**Addendum No. 1
to the Bidding Documents for**

BID PROPOSAL #09-15

**Hobbs Hill Water Tank Replacement
City of Portsmouth Department of Public Works
Portsmouth, New Hampshire**

Issued September 8, 2014

GENERAL NOTES

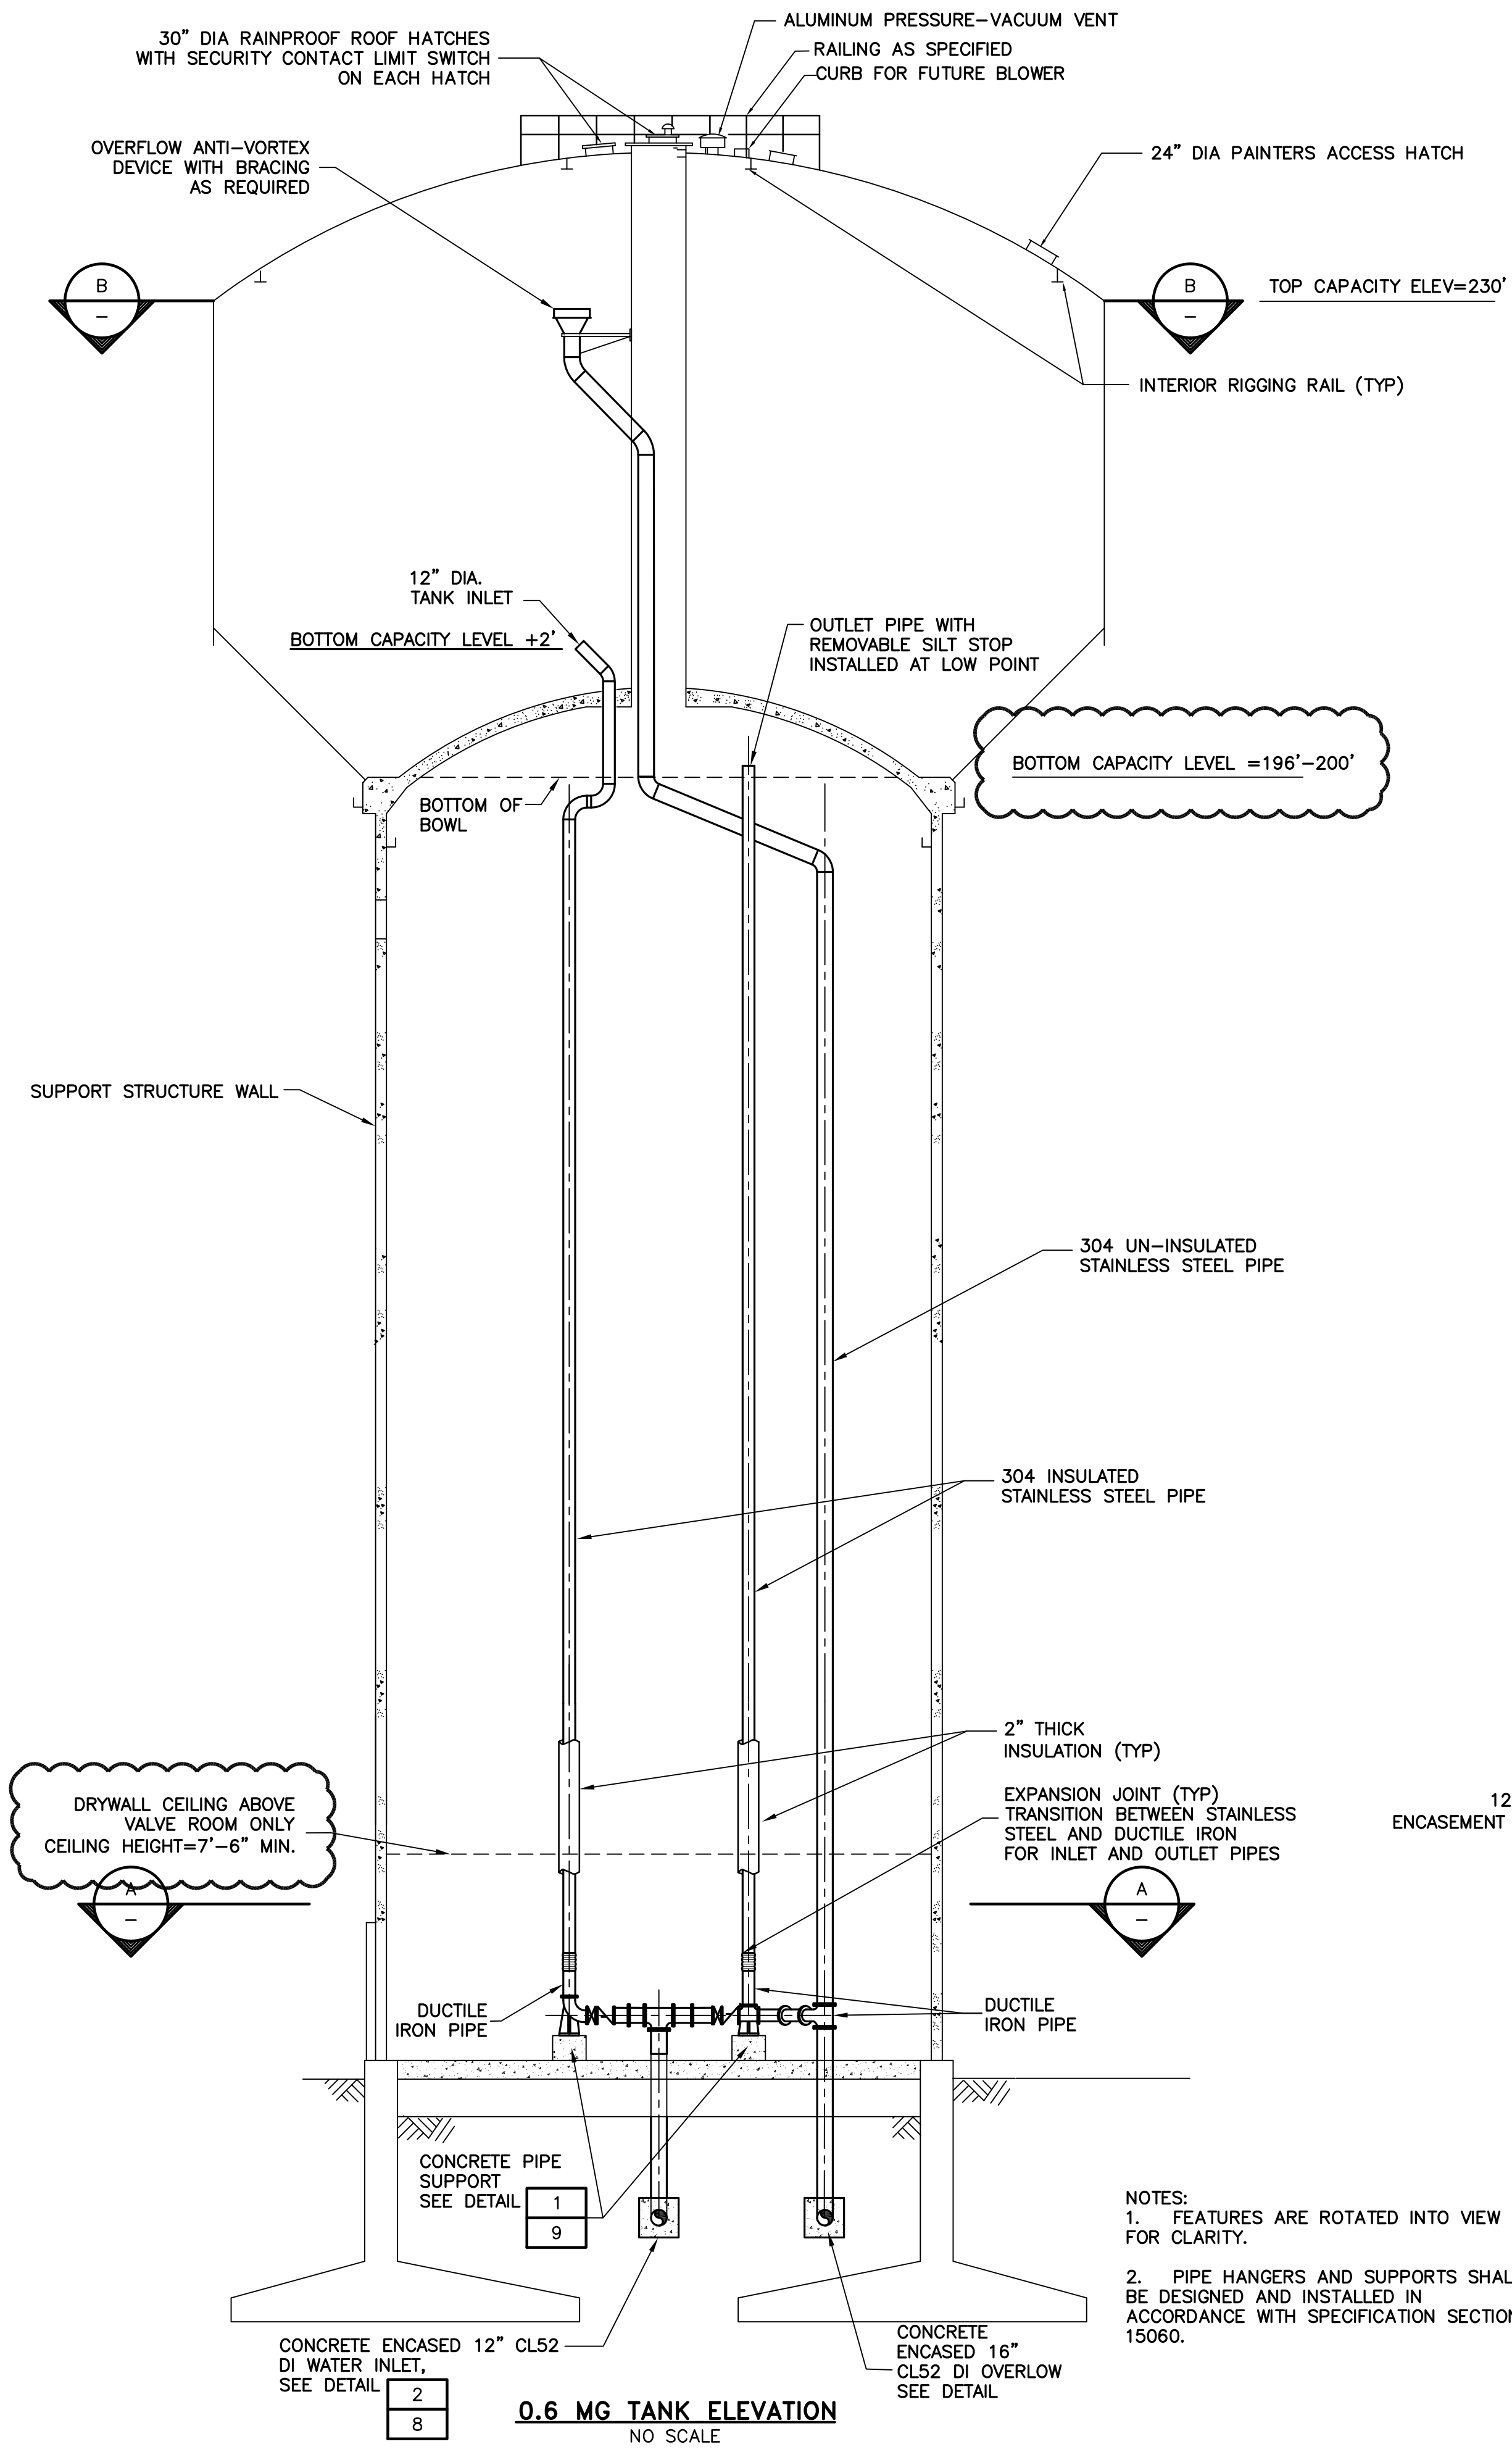
5. Can we use our standard head range of 33' (Sheet 6, Elevation and Section 13210 1.7 B)?

6. Can the overflow pipe be on the exterior of the access tube (Sheet 6, Elevation)?

The overflow pipe is currently shown as a welded penetration through the side of the 60-inch diameter access tube. The advantage is it eliminates one flanged penetration through the concrete tank bottom, which T&B believes is a greater long term maintenance issue as compare to the fabricated penetration through the access tube. An alternative configuration consisting of an overflow pipe internal to the steel tank (exterior of the access tube) and penetrating through the concrete tank

7. Can we use our galvanized rest platforms in lieu of aluminum rest seats (Sheet 6, Elevation and Section 13210 2.5 D.1)?

31. Page 13210-14 specifies a 10'x10' overhead door as does drawing sheet 6. Drawing sheet 10 specifies a 12'x12' overhead door. Please clarify door size.

32. Drawing sheet 6 shows overflow piping going through access tube. Our typical overflow pipe does not go through the access tube. Please clarify that this is acceptable.

44. The Masonry wall inside the pedestal of the tank shown on sheet 6 has no height associated with it. Please provide.

54. Sheet 6 shows the incoming waterline passing over the foundation. Our design will incorporate the incoming waterline into the foundation. Please confirm this is acceptable and we are not required to place the foundation deeper than required by our design to allow the waterline to pass over the foundation.

The following alternative Operating Parameters as described Section 13210 1.7 B will be acceptable:

Operating range (min. - max.)	25-34 feet
Bottom of Tank Bowl Elevation	196 feet minimum

bottom would be acceptable, conditional upon approved shop drawings, if it is demonstrated that it addresses the long term maintenance concerns.

Yes - galvanized rest platforms can be used in lieu of aluminum rest seats.

The overhead door size shall be 10 feet by 10 feet.

Refer to response to question #6 above.

Ceiling height shall be not less than 7'-6".

The proposed foundation the design will need to accommodate the incoming waterline configuration and these details are to be addressed as part of the shop drawing review/approval process.

TANK ELECTRICAL ELEVATION AND PLAN
SCALE: AS SHOWN
SHEET 10

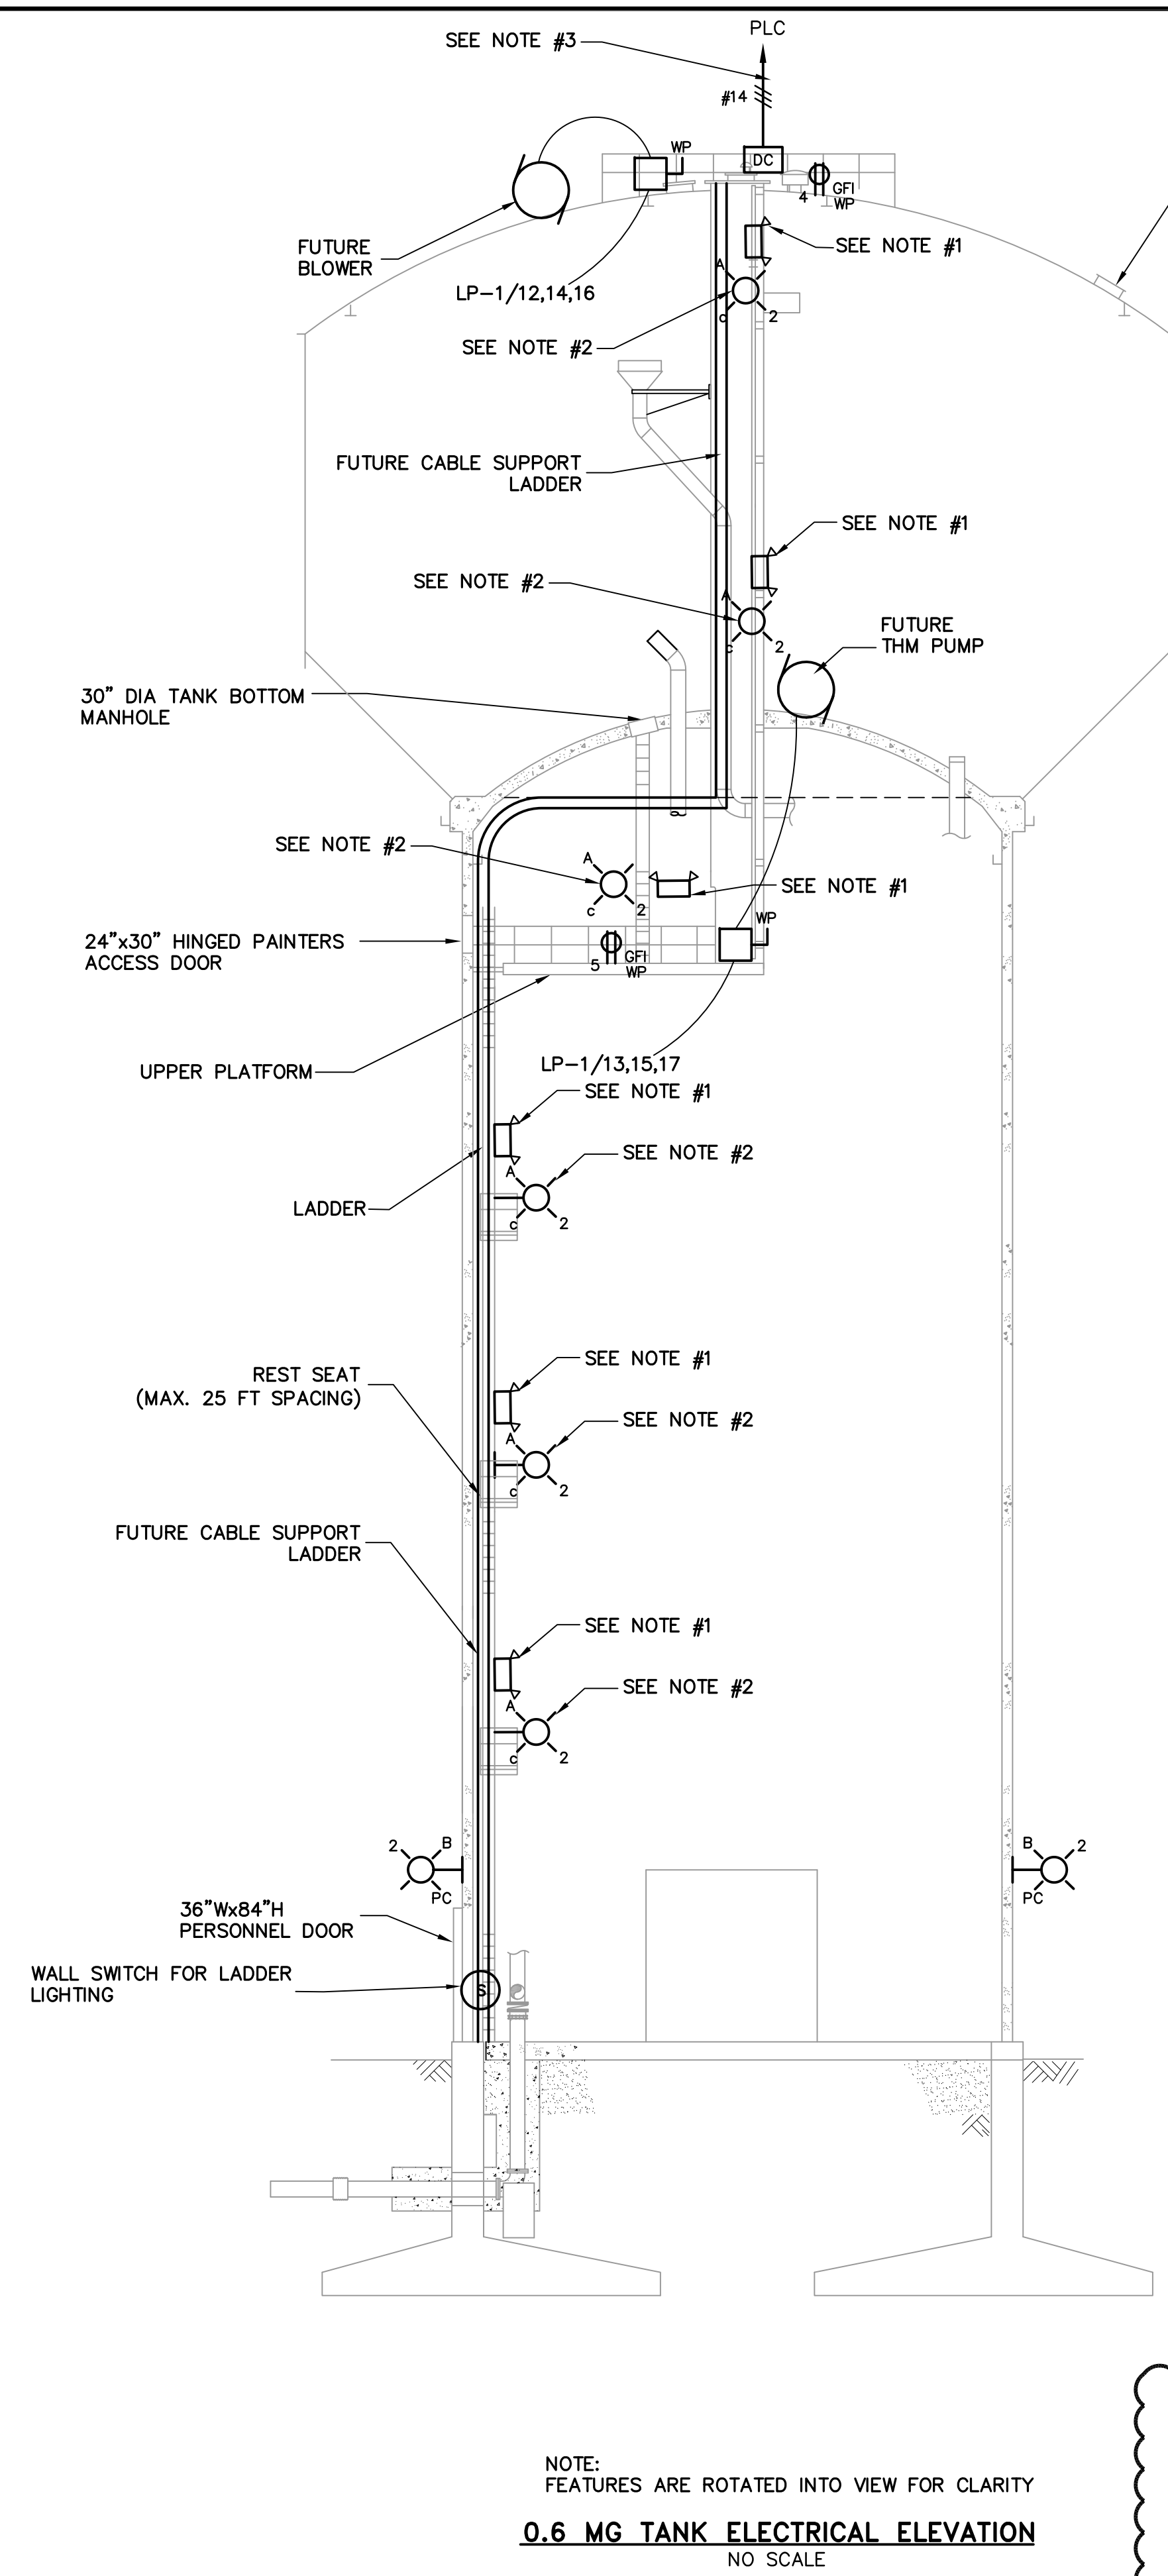
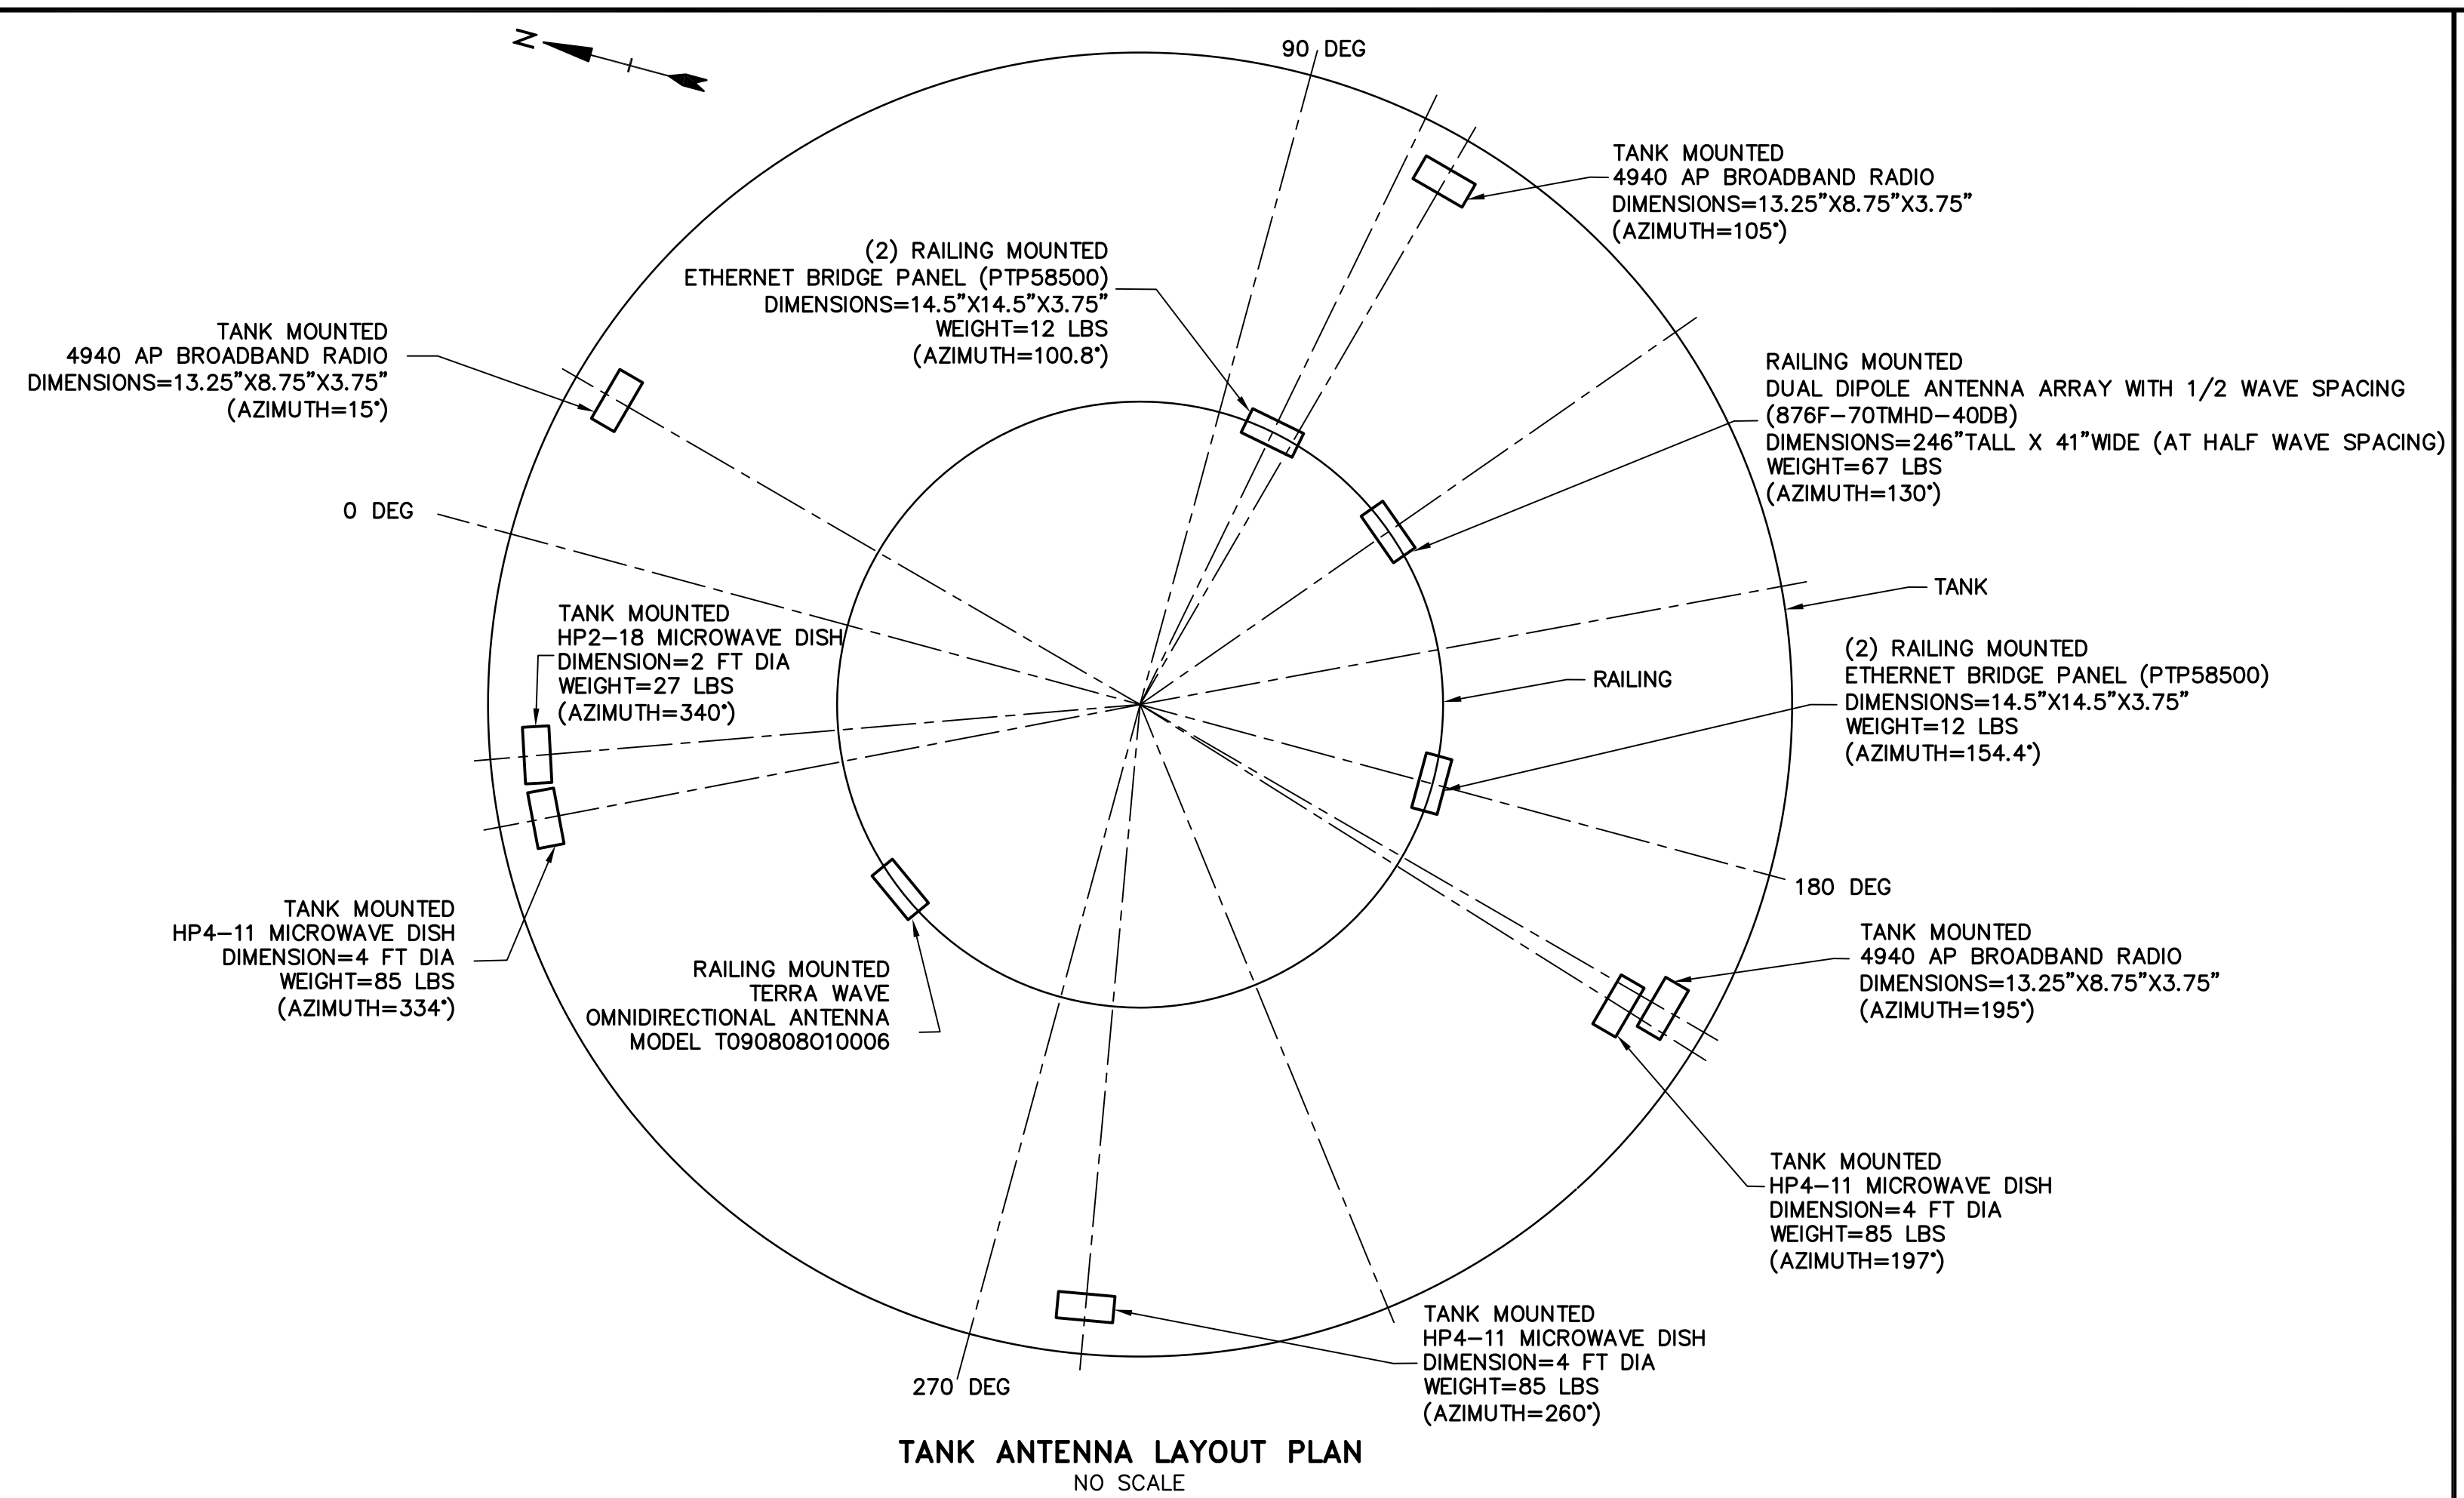
8. Are there details for mounting brackets necessary for the antennas (Sheet 10, Tank Antenna Layout Plan)?

The mounting brackets for railing mounted antennae will be provided by the contractor relocating the antenna. The locations of the railing mounted antenna were provided to ensure that the railing/tank design takes into account the loads associated with them. The mounting brackets for the tank mounted antennae will be furnished and installed by the contractor relocating the antennae. The timing of installation and final location for antenna support bracket fabrication will need to be coordinated with the antenna contractor prior to painting. The locations of the tank mounted antenna were provided to ensure that the structural design takes into account the loads associated with them.
